Access Compliance Report

Public Rights-of-Way

(Curb Ramps)

Intersection ID: 19048	Main Street: CORY-BRET_LN	Cross Street: SHOPTON_RD_WEST	Location: NW
ADA ID: 9BCC88CE3F77	Ramp Type: Directional1	Initial Pass/Fail: Fail	Overall Compliance: No
		Severity Score: 12.5	
Codes/Mitigation Info/Possible Solution		Field Measurements/Component Compliance

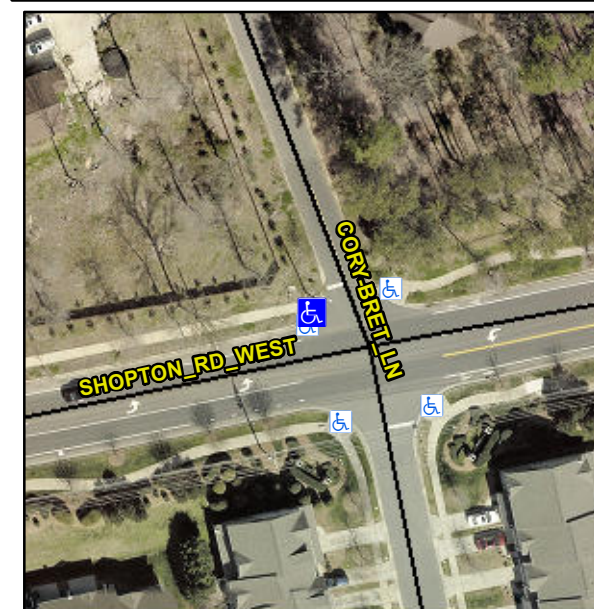
R304.5.3

Compliance	Description	Data	Compliance	Description	Data
N/A	Ramp Length (in)	103.0	N/A	Grade Break?	N/A
Yes	Ramp Width (in)	70.0	N/A	Grade Break Slope (%)	0.0
Yes	Ramp Slope (%)	2.2	N/A	Grade Break XSlope (%)	0.0
No	Ramp XSlope (%)	6.1			
N/A	Flare Type LT	N/A	N/A	Flare Type RT	N/A
N/A	Flare Slope LT (%)	N/A	N/A	Flare Slope RT (%)	0.0
N/A	Flare Traversable LT?	N/A	N/A	Flare Traversable RT?	N/A
N/A	Landing Length (in)	0.0	N/A	DWS Provided?	N/A
N/A	Landing Width (in)	0.0	N/A	DWS Contrast?	N/A
N/A	Landing Slope (%)	0.0	N/A	DWS Length (in)	N/A
N/A	Landing X Slope (%)	0.0	N/A	DWS Full Width?	N/A
N/A	Landing Curb? (Y/N)	N/A	N/A	DWS Offset LT (in)	N/A
N/A	Shared Landing?	N/A	N/A	DWS Offset RT (in)	N/A
N/A	Gutter Ponding?	0.0	N/A	Gutter Slope (%)	N/A
N/A	Gutter Lip Ht (in)	0.0	N/A	Gutter X Slope (%)	N/A
N/A	Painted X Walk1?	No		Road Slope (%)	0.6
	X Walk 1 Direction	To NE		Road X Slope (%)	4.6
	X Walk 1 Width (in)	N/A		Clear Space?	N/A

X Walk 1 Slope (%)	0.6	N/A	Clear Space to XWalk (in)	N/A
	X Walk 1 X Slope (%)	4.6	N/A	Storm Grate/Utility Hazard?	N/A
N/A	Ramp inside XWalk1?	N/A		Storm Grate/Utility Type	
N/A	Any Obstructions?	N/A			N/A
	Obstruction Type		Yes	Surface Condition? (G/P)	Good
			N/A	Curb Slope (%)	0.7

Remove & Replace Entire Ramp.
